PROJECT: LAND WEST OF CRAWLEY DOWN

Stage 1 Road Safety Audit

Proposed Site Access Arrangements onto Turners Hill Road

Report Ref: 22042-3

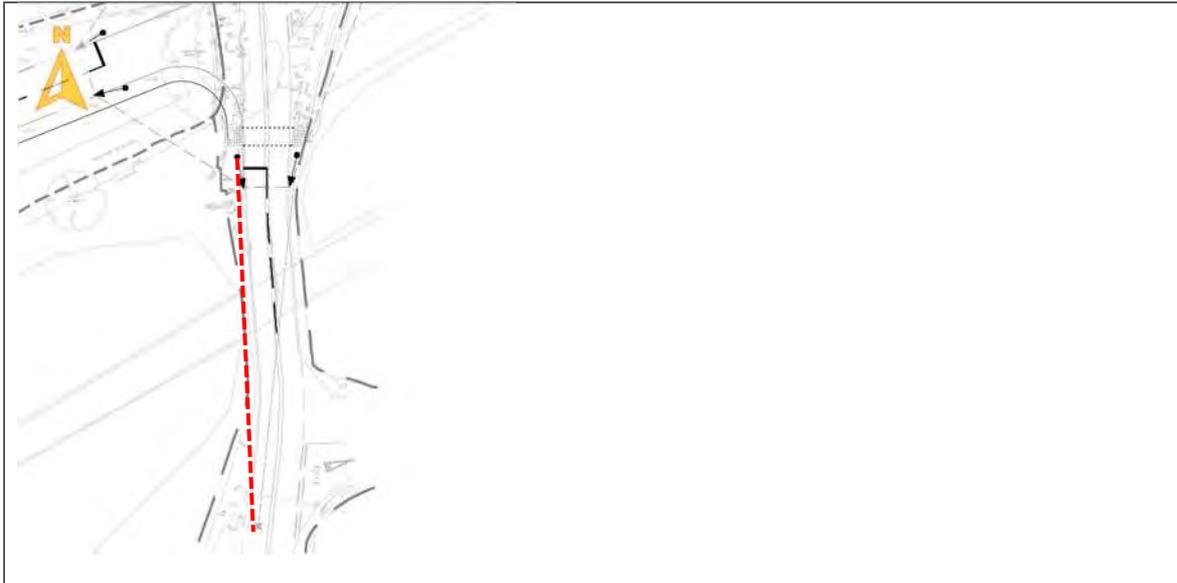
4.1	LOCAL ALIGNMENT
	No road safety concerns raised at this stage.
4.2	GENERAL
4.2.1	Problem
Location:	Turners Hill Road Southern Arm
Summary:	Insufficient visibility to primary signal head
<p>The scheme includes the provision of a new access on the western side of Turners Hill Road and the signalling of the junction arrangement at Turners Hill Road / Vicarage Road / Proposed Site Access. Primary signal heads are shown on either side of the carriageway on all arms. Visibility in accordance with the recorded 85th percentile speed of 33.33mph, which is identified to equate to 49.9 metres in accordance with Manual for Streets criteria, is shown to a signal head located on the eastern side of Turners Hill Road for the northbound approach, however, no visibility splay is shown to the signal head located on the western side of Turners Hill Road. The Audit Team have concerns that if the signal head on the eastern side fails, there may be insufficient visibility to the signal head on the western side. Furthermore, that a high sided southbound vehicle could obstruct the signal head on the eastern side of the carriageway. Insufficient visibility could result in an approaching driver failing to notice a red signal ahead with sufficient time to stop, leading to junction overshoots, heavy vehicle braking and loss of control type incidents.</p>

Recommendation:	
It is recommended that an appropriate level of visibility to the primary signal head on the eastern side of Turners Hill Road is achievable.	
Location Plan:

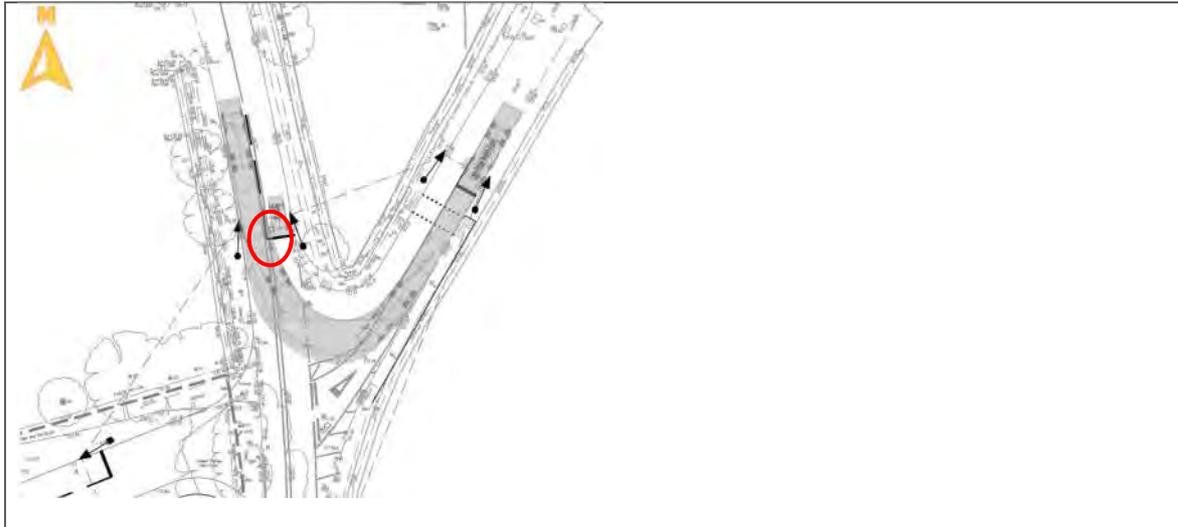
4.2.2	Problem
Location:	Scheme
Summary:	Arrangement may not be adequate to accommodate the expected vehicles
<p>The scheme includes the provision of a new access on the western side of Turners Hill Road and the signalling of the junction arrangement at Turners Hill Road / Vicarage Road / Proposed Site Access. Swept path analysis of a Refuse / Recycling Collection Vehicle (RCV) undertaking various manoeuvres at the junction has been provided. The swept path analysis of a RCV turning right out of Vicarage Lane is shown to successfully pass a stationary car at the stop line, however, the RCV is shown to cross the centreline at the stop line. The Audit Brief identifies Heavy Goods Vehicles (HGV's) can be expected to negotiate north / south through the junction. There is a risk a right turning RCV may be unable to pass a stationary HGV at the stop line. Insufficient space to enable the two vehicles to pass could result in sideswipes or the need for one of the drivers to reverse, potentially leading to rear end collisions or collisions with kerbs / adjacent infrastructure.</p>

Recommendation:	
It is recommended that the scheme allows for the expected vehicles and manoeuvres.	
Location Plan:

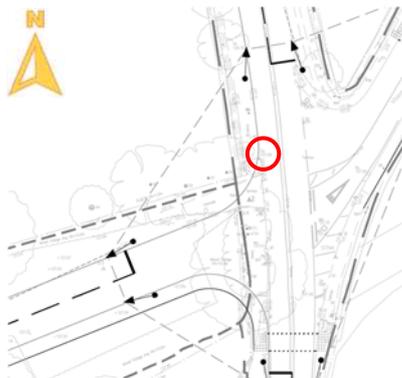
4.2.4

Turners Hill Road – Proposed Access

Surface water may not drain sufficiently

Turners Hill Road is a single carriageway two-way road that is subject to a 30mph speed limit in the vicinity of the scheme and accommodates a crossfall, encouraging surface water to flow to the western side of the carriageway where it drains to a drainage ditch. The scheme includes the provision of a new access on the western side of Turners Hill Road and the signalling of the junction arrangement at Turners Hill Road / Vicarage Road / Proposed Site Access. At the location of the proposed access an existing road gully is present. No drainage details have been provided at this stage, however, the removal of the road gully will increase the amount of surface water that will flow across Turners Hill Road and the proposed access, which could lead to surface water ponding and loss of control type incidents, particularly during inclement and freezing conditions.

It is recommended that the proposals allow for surface water to drain sufficiently.

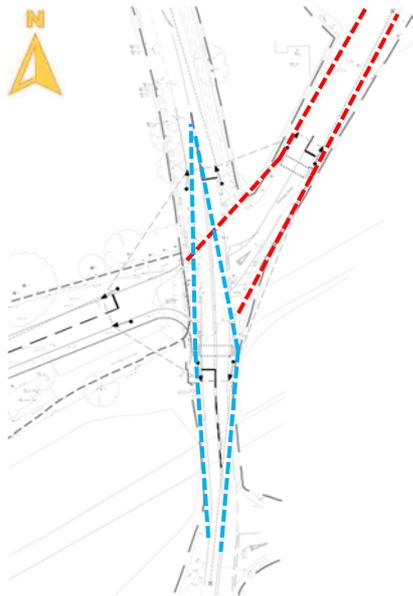
Recommendation:	
It is recommended that an appropriate level of junction intervisibility is achievable.	
Location Plan:	
4.4	NON-MOTORISED USER PROVISION
4.4.1	Problem
Location:	Scheme
Summary:	Insufficient visibility to / from users at the uncontrolled crossing points
<p>Turners Hill Road is a single carriageway two-way road that is subject to a 30mph speed limit in the vicinity of the scheme, with an existing uncontrolled pedestrian crossing</p>

present on the southern radius of Vicarage Road within the vicinity of the scheme. The scheme includes the provision of a new access on the western side of Turners Hill Road and the signalling of the junction arrangement at Turners Hill Road / Vicarage Road / Proposed Site Access and the relocation and signalling of the existing uncontrolled pedestrian crossing on Vicarage Road, south of its existing location. The Audit Brief identifies visibility splays of 38.3 metres on Vicarage Road and 61.7 metres and 49.9 metres to the north and south on Turners Hill Road respectively, however, no visibility splays have been shown for users at the proposed crossing points. The Audit Team are unsure if suitable visibility is achievable from the crossing points, particularly on Vicarage Road where visibility appears restricted by the vegetation, bridge parapets and guard railing. Limited visibility from and to a crossing point could lead to a pedestrian / cyclist entering into the path of an approaching vehicle, resulting in a vehicle to pedestrian / cyclist collision or heavy vehicle braking and loss of control.

It is recommended that sufficient visibility to / from the crossing points is achievable and that any obstructions, to include vegetation and street furniture, within the visibility splay envelopes are cleared, and maintained clear, to ensure an appropriate level of visibility is achievable.

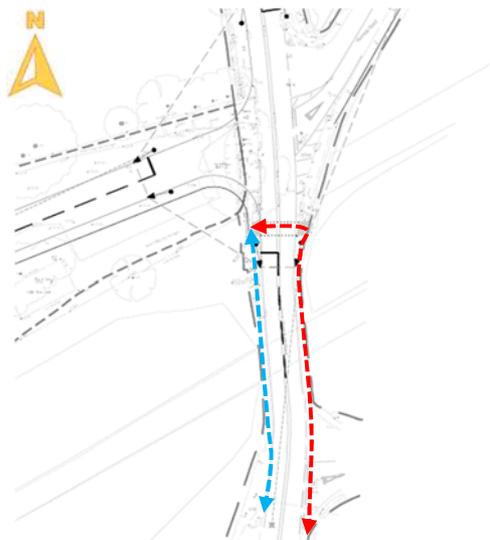
4.4.2	Problem
Location:	Turners Hill Road
Summary:	Insufficient facilities for footway users along a likely desire line
Turners Hill Road is a single carriageway two-way road that is subject to a 30mph speed limit in the vicinity of the scheme. A footway is present on the eastern side of Turners Hill Road, with the closest bus stops located on Turners Hill Road, some 100 metres to the

south and some 800 metres north. The scheme includes the provision of a new access on the western side of Turners Hill Road and the signalling of the junction arrangement at Turners Hill Road / Vicarage Road / Proposed Site Access, alongside the provision of signal controlled pedestrian crossings on the Vicarage Road and Turners Hill Road (south) arms. A desire line will be present southbound to / from the closest bus stops, where a post box is also present on the western side of Turners Hill Road. While a proposed controlled crossing is illustrated to the south on Turners Hill Road, a lack of crossing facilities at the Turners Hill Road / Grange Road junction and at the bus stops could lead to pedestrians continuing via the narrow footway over the bridge and the grass verge on the western side of Turners Hill Road. If opposed by other users a pedestrian could enter the live carriageway where vehicles are manoeuvring, potentially into the path of vehicles, resulting in vehicle to pedestrian collisions.

It is recommended that measures are provided to discourage pedestrians from continuing southbound via the narrow footway over the bridge and grass verge on the western side of Turners Hill Road and that suitable facilities are provided at the Turners Hill Road / Grange Road junction and at the northbound bus stop to encourage pedestrians to navigate via the existing footway on the eastern side of Turners Hill Road.

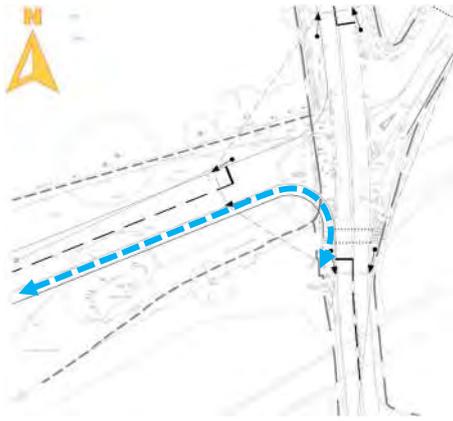
4.4.4

Turners Hill Road / Proposed Access

Insufficient facilities to accommodate pedestrians and cyclists along a likely desire line

Turners Hill Road is a single carriageway two-way road that is subject to a 30mph speed limit in the vicinity of the scheme. A footway is present on the eastern side of the Turners Hill Road that connects to Worth Way, an 11km footpath and bridleway linking Crawley and East Grinstead via the village of Crawley Down, access to which is currently gained on the western side of Turners Hill Road via an uncontrolled crossing. The scheme includes the provision of a new access on the western side of Turners Hill Road, with a 2 metre wide footway on the southern side that provides a direct connection to the Worth Way footpath and bridleway. Residents of the potential development will be expected to travel to / from Worth Way by foot and cycle. The Audit Team is concerned that the proposed 2 metre wide footway is not wide enough to accommodate pedestrians and cyclists. An inadequate width footway / cycleway could lead to cyclist to pedestrian collisions or pedestrians / cyclists attempting to enter / exit the footway where full height kerbs are present, which could destabilise a cyclist, leading to a fall and personal injury

It is recommended that the proposed footway on the southern side of the access road and its connection with Worth Way are sufficient to accommodate pedestrians and cyclists.

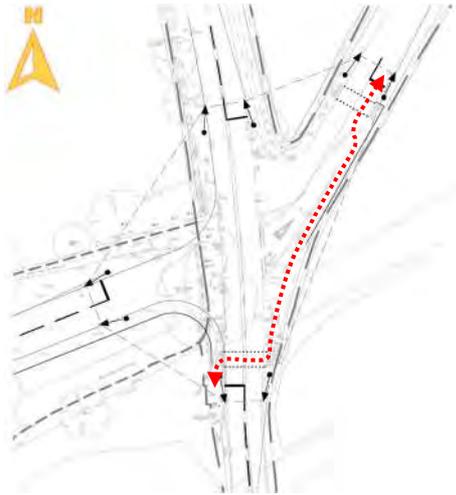
4.4.5	Problem
Location:	Turners Hill Road / Vicarage Road
Summary:	Insufficient facilities to accommodate pedestrians and cyclists along a likely desire line

Turners Hill Road and Vicarage Road are single carriageway two-way roads that are subject to a 30mph speed limit in the vicinity of the scheme. Footways are present on the eastern side of Turners Hill Road and the northern side of Vicarage Road. The scheme includes the provision of a new access on the western side of Turners Hill Road, two signal controlled pedestrian crossings on Vicarage Road and Turners Hill Road and a section of 1.5 metre wide footway on the southern side of Vicarage Road, enabling a connection between the two proposed signal controlled pedestrian crossings. Cyclists travelling between the northeast / centre of Crawley Down and the Worthy Way footpath and bridleway, are likely to utilise the proposed footway on the southern side of Vicarage Road and the proposed signal controlled pedestrian crossing on Turners Hill Road, within the vicinity of the entrance / exit to Worthy Way. There is a concern the proposed 1.5 metre wide footway and the proposed signal controlled pedestrian crossings are insufficient to accommodate both cyclists and pedestrians that can be expected to utilise them. An inadequate width footway and signal controlled crossing could lead to cyclist to pedestrian collisions or pedestrians / cyclists attempting to enter / exit the footway where full height kerbs are present, which could destabilise a cyclist, leading to a fall and personal injury or potentially vehicle to cyclist collisions and pedestrian trips and falls or potentially vehicle to pedestrian collisions.

It is recommended that dedicated cycle on and off-slips, with associated giveway markings, are provided where appropriate, that the footway and proposed signal controlled pedestrian crossing on Turners Hill Road are suitable to accommodate pedestrians and cyclists and that advance warning, to include hazard warning paving, are provided.

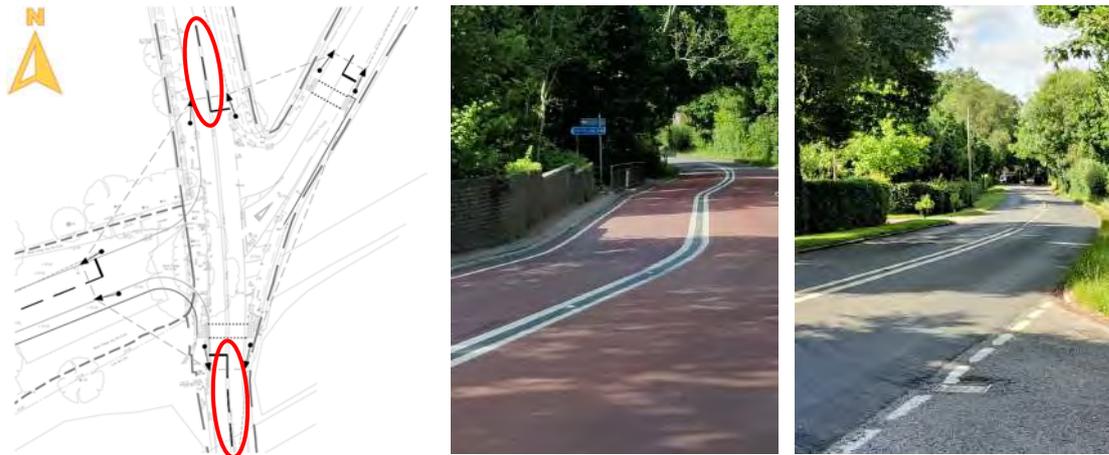
4.5.1 Problem

Summary: Vehicles could attempt to overtake where it is not safe to do so

Turners Hill Road is a single carriageway two-way road that is subject to a 30mph speed limit in the vicinity of the scheme. The centreline road markings on Turners Hill Road within the vicinity of Vicarage Lane comprise of double solid lines prohibiting vehicles crossing into the opposing lane unless certain criteria is met. The scheme includes the provision of a new access on the western side of Turners Hill Road and the signalling of the junction arrangement at Turners Hill Road / Vicarage Road / Proposed Site Access, with dashed centreline road markings to diagram 1004 shown on the approaches. Road markings to diagram 1004 do not prohibit vehicles from crossing into the opposing lane. The Audit Team have concerns that the provision of the dashed road centreline marking, in place of the existing road markings that prohibit traffic crossing into the opposing lane, could result in drivers attempting to overtake where it is not safe to do so, which could lead to front end, sideswipe or sudden braking and loss of control type incidents.

It is recommended that the road markings are amended accordingly.

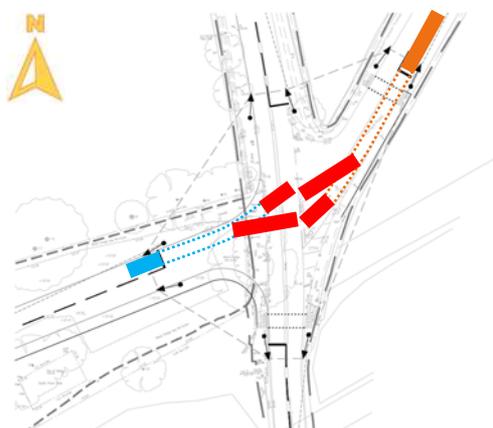
4.5.2	Problem
Location:	Scheme
Summary:	Turning vehicles could obstruct vehicles travelling through the junction

Turners Hill Road is a single carriageway two-way road that is subject to a 30mph speed limit in the vicinity of the scheme. The scheme includes the provision of a new access on the western side of Turners Hill Road and the signalling of the junction arrangement at Turners Hill Road / Vicarage Road / Proposed Site Access. A review of the staging information contained within the Audit Brief indicates that both the Vicarage Road and Proposed Site Access arms are to operate at the same time / in the same stage and with all movements allowed. No road markings are illustrated on the scheme drawings to identify suitable locations for vehicles waiting to turn / entering the centre of the junction. The Audit Team are concerned that the lack of road markings could result in vehicles waiting to turn blocking and / or obstructing through vehicle movements, which could lead to sudden braking and loss of control or side / rear collisions.

It is recommended that road markings are provided to direct drivers through the junction.

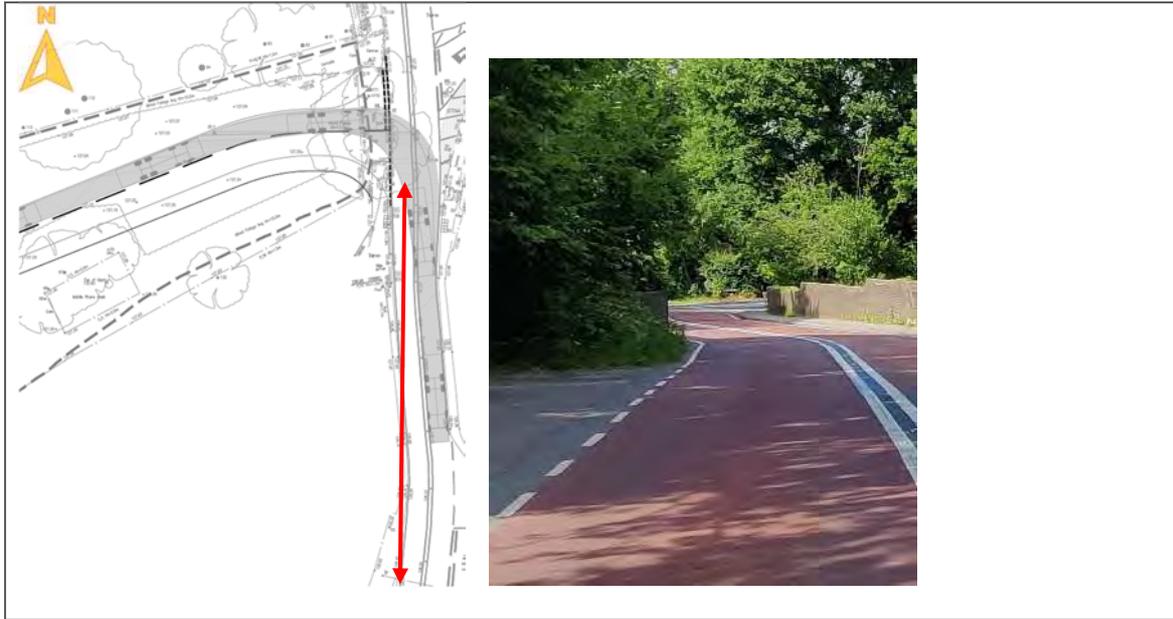
4.1	LOCAL ALIGNMENT
	No road safety concerns raised at this stage.
4.2	GENERAL
4.2.1	Problem
Location:	Turners Hill Road – Proposed Access
Summary:	Insufficient visibility to the rear of a Refuse / Recycling Collection Vehicle
<p>Turners Hill Road is a single carriageway two-way road that is subject to a 30mph speed limit in the vicinity of the scheme. The scheme includes the provision of a new simple priority access on the western side of Turners Hill Road. The Scheme drawings provided with the Audit Brief illustrate visibility splays of 61.7 metres and 49.9 metres to the north and south on Turners Hill Road respectively. Swept path analysis of a Refuse / Recycling Collection Vehicle (RCV) manoeuvring into and out of the proposed access has been provided. The swept path analysis of a RCV turning right out of the access identifies that the trailer of the RCV remains in the northbound opposing lane for an extended period of time upon having exited the access. It is unclear from the drawings provided if sufficient forward visibility between a northbound vehicle and the rear of the RCV, while it is in the opposing lane, is achievable. There is a risk a vehicle travelling northbound may not have sufficient clear forward visibility to the rear of the RCV while it is in the opposing lane, which could result in a vehicle failing to stop in time, leading to rear end / side impact collisions.</p>

Recommendation:	
It is recommended that sufficient clear forward visibility to the rear of the RCV while it is in the opposing lane is achievable.	
Location Plan:

RSA Problem	RSA Recommendation	Design Organisation Response	Overseeing Organisation Response	Agreed RSA Action
<p>4.2.1 The swept path analysis of a RCV turning right out of the access identifies that the trailer of the RCW remains in the northbound opposing lane for an extended period of time upon having exited the access. It is unclear from the drawings provided if sufficient forward visibility between a northbound vehicle and the rear of the RCV, while it is in the opposing lane, is achievable. There is a risk a vehicle travelling northbound may not have sufficient clear forward visibility to the rear of the RCV while it is in the opposing lane, which could result in a vehicle failing to stop in time, leading to rear end / side impact collisions.</p>	<p>It is recommended that clear forward visibility to the rear of the RCV while it is in the opposing lane is achievable.</p>	<p>Accepted – Drawing ITB9155-GA-034B (included at the back of this note) demonstrates that there is sufficient clear forward visibility to the right turning RCV and drawing ITB9155-GA-031C (appended to the TA and at the back of this note) demonstrates that a refuse vehicle and large estate car can manoeuvre safely pass each other in all directions.</p>

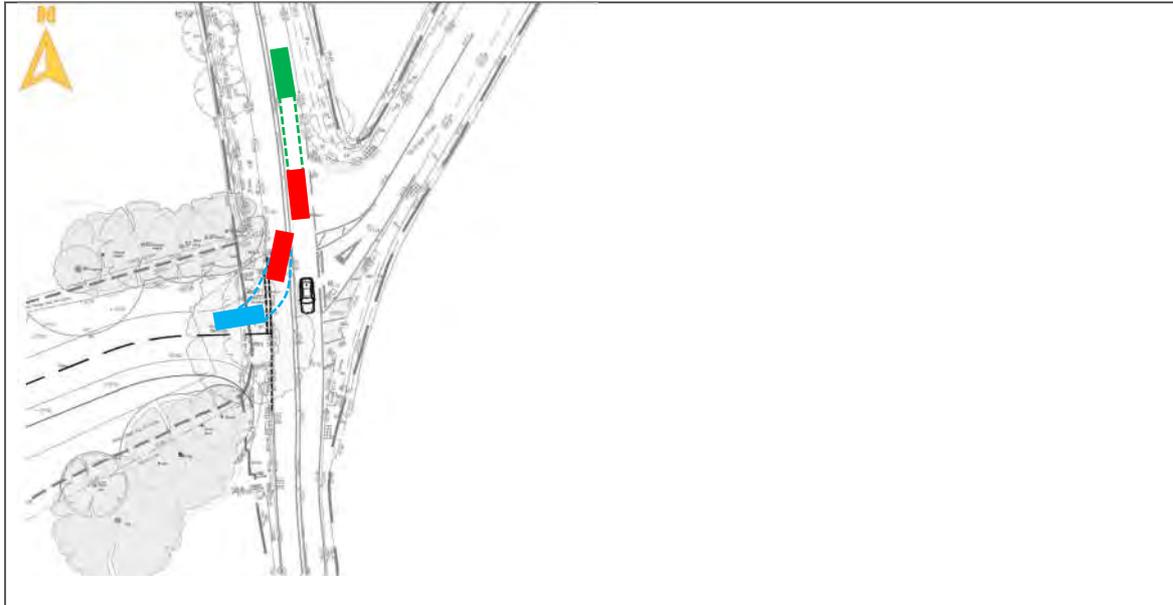
4.3.2	Problem
Location:	Turners Hill Road – Proposed Access
Summary:	Waiting right turning vehicles could encroach the opposing lane
<p>Turners Hill Road is a single carriageway two-way road that is subject to a 30mph speed limit in the vicinity of the scheme. The scheme includes the provision of a new simple priority access on the western side of Turners Hill Road, forming a left / right stagger junction arrangement with Vicarage Road. Swept path analysis of a Refuse / Recycling Collection Vehicle (RCV) undertaking various manoeuvres at the junction has been provided. The swept path analysis of the RCV illustrates the vehicle going straight across between the minor arms. Vehicles expected to visit the site on a regular basis are unlikely to negotiate straight across the junction and instead undertake a left turn out and wait in the Turners Hill Road carriageway prior to turning right into the opposite arm. It is unclear from the drawings provided if vehicles expected to visit the site on a regular basis, such as cars and delivery vehicles, can undertake this manoeuvre without the need to wait / overhang the opposing lane, which could result in sideswipe / front end collisions.</p>

Recommendation:	
<p>It is recommended that sufficient space is available to enable vehicles expected to visit the site on a regular basis to undertake this manoeuvre without the need to wait / overhang the opposing lane.</p>	
Location Plan:

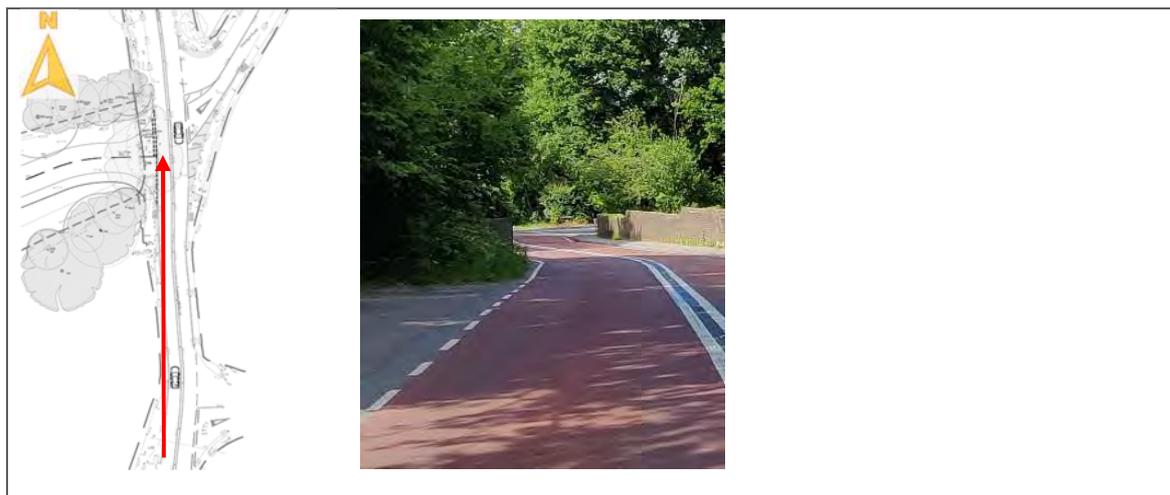
4.3.3	Problem
Location:	Turners Hill Road – Proposed Access
Summary:	Northbound vehicles approaching the proposed access arrangement may not have clear visibility of turning traffic
<p>Turners Hill Road is a single carriageway two-way road that is subject to a 30mph speed limit in the vicinity of the scheme. The scheme includes the provision of a new simple priority access on the western side of Turners Hill Road. The Audit Brief identifies a speed survey was undertaken that recorded 85th percentile northbound and southbound speeds of 33.33mph and 38.48mph respectively. It is understood that the visibility splays of 49.9 metres and 61.7 metres have been provided to the south (right) and north (left) in accordance with the Stopping Sight Distance (SSD) set out in Manual for Streets (MfS). The audit team have concerns that, due to the alignment of the Turners Hill Road carriageway to the south, the presence of the bridge parapet and the guard railing on to the western side of Turners Hill Road, approaching northbound traffic may not have clear visibility of a vehicle waiting to turn right into or having just turned left / right out of the proposed access. Restricted forward visibility to a priority access could lead to rear end and side impact collisions or heavy braking and loss of control.</p>

Recommendation:	
<p>It is recommended that suitable advance warning, such as ‘Side Road Ahead’ / ‘Separated Junction Ahead’, is provided south of the bridge over Worth Way for northbound vehicles travelling on Turners Hill Road on the approach to the proposed access.</p>	
Location Plan:

RSA Problem	RSA Recommendation	Design Organisation Response	Overseeing Organisation Response	Agreed RSA Action
<p>4.3.3 The Audit Brief identifies a speed survey was undertaken that recorded 85th percentile northbound and southbound speeds of 33.33mph and 38.48mph respectively. It is understood that the visibility splays of 49.9 metres and 61.7 metres have been provided to the south (right) and north (left) in accordance with the Stopping Sight Distance (SSD) set out in Manual for Streets (MfS). The audit team have concerns that, due to the alignment of the Turners Hill Road carriageway to the south, the presence of the bridge parapet and the guard railing on to the western side of Turners Hill Road, approaching northbound traffic may not have clear visibility of a vehicle waiting to turn right into or having just turned left / right out of the proposed access. Restricted forward visibility to a priority access could lead to rear end and side impact collisions or heavy braking and loss of control.</p>	<p>It is recommended that suitable advance warning, such as 'Side Road Ahead' / 'Separated Junction Ahead', is provided south of the bridge over Worth Way for northbound vehicles travelling on Turners Hill Road on the approach to the proposed access.</p>	<p>Accepted – A 'Side Road Ahead' warning sign has been added to Drawing ITB9155-GA-029I.</p>
